**NOTICE OF FINAL  
FINDINGS, CONCLUSIONS AND DECISION  
OF THE CITY OF PORTLAND HISTORIC LANDMARKS COMMISSION  
ON AN  
APPEALED ADMINISTRATIVE DECISION  
(Type II Process)**

**CASE FILE: LU 13-113608 HDZ – 1321 SE Birch Alterations**

**LOCATION: 1321 SE Birch St.**

CASE NO. W 13-113608 H02  
EXHIBIT: C-2

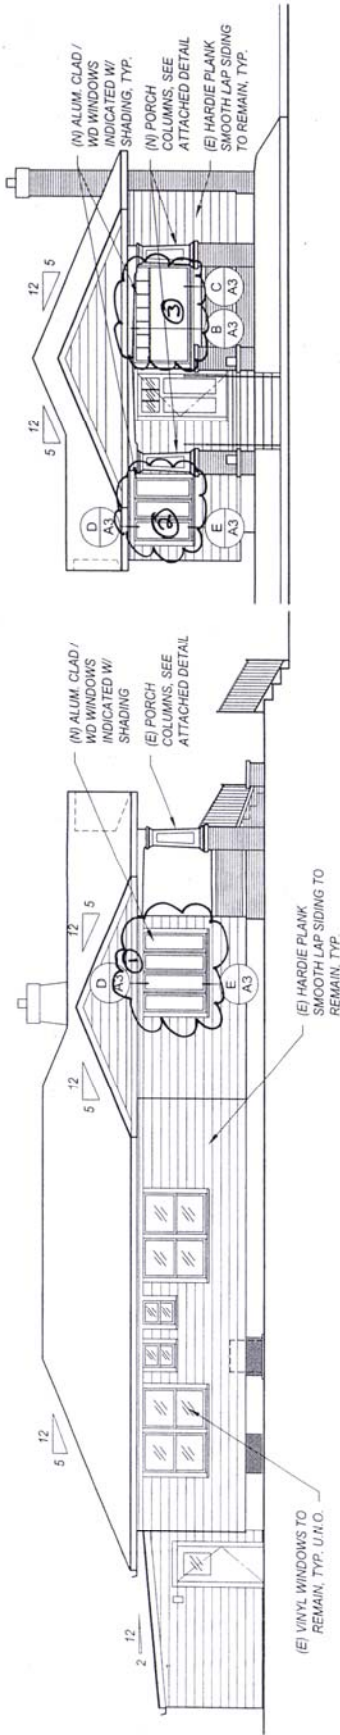
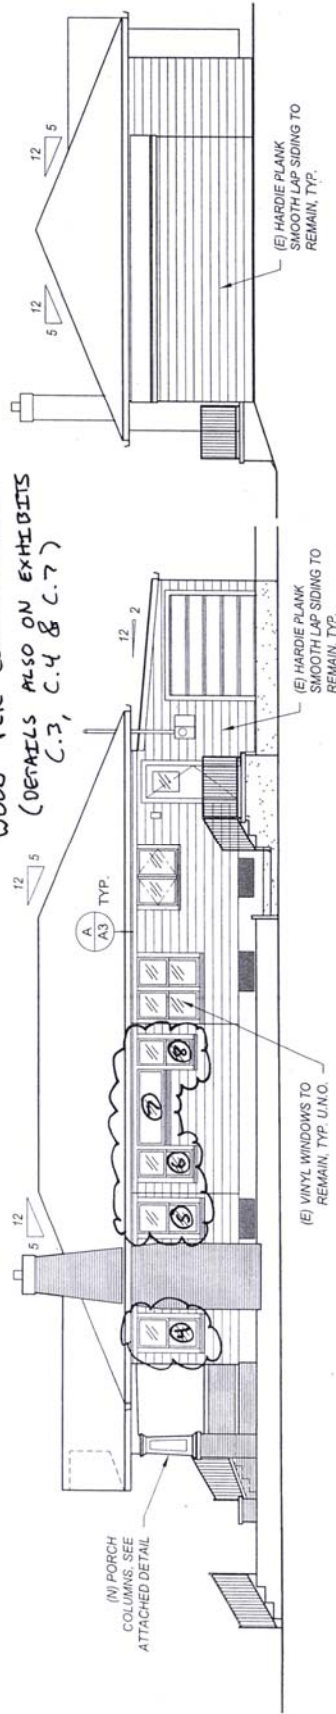
To adequately improve the front portions of the home most visible from the street consistent with this guideline and compromise position, Landmarks Commission determined that additional vinyl windows must be replaced with the inset metal-clad wood windows. With a condition of approval imposed during the final motion on the appeal decision, Landmarks Commission determined the applicant's compromise proposal satisfied this guideline. The condition requires that two separate groups of windows must be replaced; (1) the three front and west side banks of windows as proposed in the appeal package, and (2) the first five windows closest to the street on

the east elevation (two hung windows flanking the chimney, two hung and one fixed dining room window). The windows affected in this condition of approval are numbered 1-8 on the approved elevations, Exhibit C.2, for clarity.

- A. In addition to the three banks of vinyl windows proposed to be replaced on the south/front and west/side facades of the home, the applicant shall remove vinyl windows as installed and replace these with inset metal-clad wood windows per previous details in the case file on the east/alley elevation at the two hung windows straddling the fireplace, and at the two hung and single fixed windows of the dining room just beyond. The entire group of specific windows which must be changed from flush vinyl to inset metal-clad wood are numbered 1-8 on Exhibit C.2.

WINDOWS # ① → ⑧  
TO BE REPLACED WITH  
INSET METAL CLAD  
WOOD PER CONDITION A.  
(DETAILS ALSO ON EXHIBITS  
C.3, C.4 & C.7)
